City of Franklin

Franklin Municipal Planning Commission

Thursday, May 23, 2019

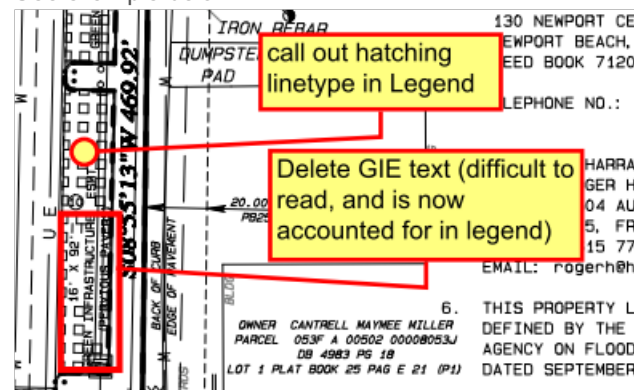
For legibility purposes, Applicant to update the legend to reflect the Green Infrastructure Easement hatching linetype added in the latest submittal, and remove the Green Infrastructure text from within the hatching on the plat which is currently difficult to read.

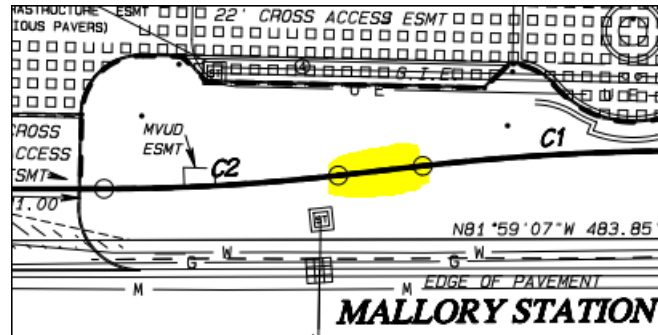
joe.marlo@franklntn.gov The following item was overlooked on the initial review, but needs to be corrected.

Applicant to provide metes and bounds for all property lines, including that highlighted below.

Median in Liberty Pike at the intersection with Carothers Parkway

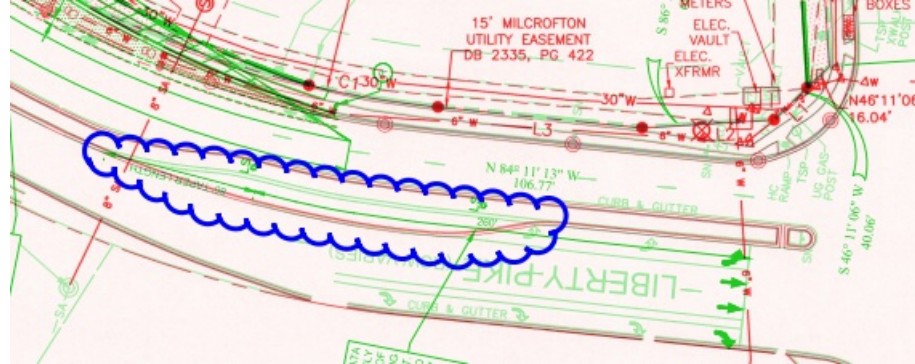
1. Modified median in Liberty Pike at the intersection with Carothers Parkway.
2. Modified median in Carothers Parkway at the intersection with Southstar Drive.

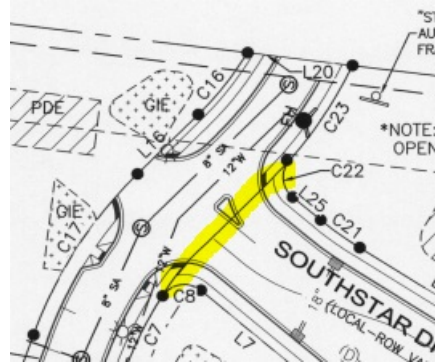
joe.marlo@franklin.tn.gov Comment not adequately addressed, as the line remains to be shown (Sheet 5).

Applicant to remove line between Edward Curd Lane and Southstar Drive highlighted below.

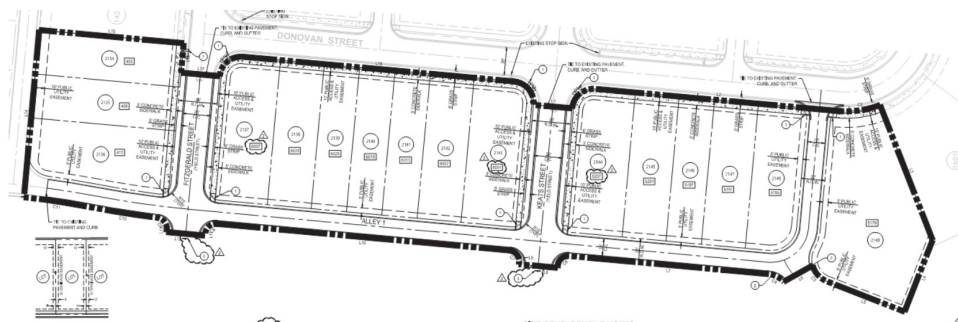
lance.fittro@franklin.tn.gov The "Phase Line" notation is still shown in one location, and shall be changed to read "Section Line."

Additionally, the section line should encompass all lots and ROW dedication for this section so that it is clear what portion of ROW is being dedicated. Applicant shall correctly show the entire Section 55 boundary on the plat to match that shown on the Section 55 Site Plan, and provide meets and bounds calls where absent:

9. Temporary Turnarounds

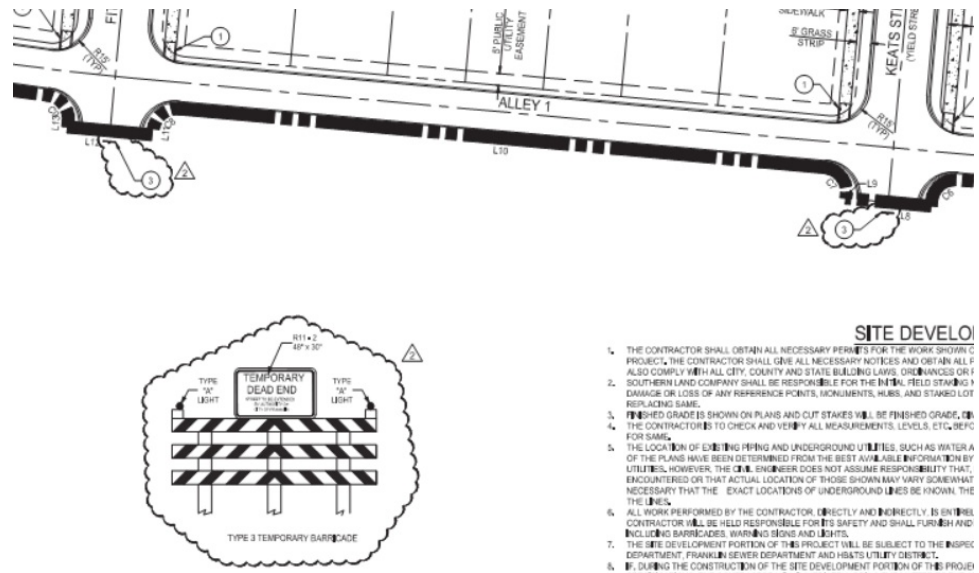
lance.fittro@franklin.tn.gov Applicant shall remove the temporary culs-de-sac and easements that were added to the plat with this submittal, and just indicate the location of the "Street To Be Extended" signs at the ends of the street stubs as was shown on the Section 55 site plan. Staff recommends changing the words "temporary turnarounds" in the note to "street stubs" to avoid further confusion.
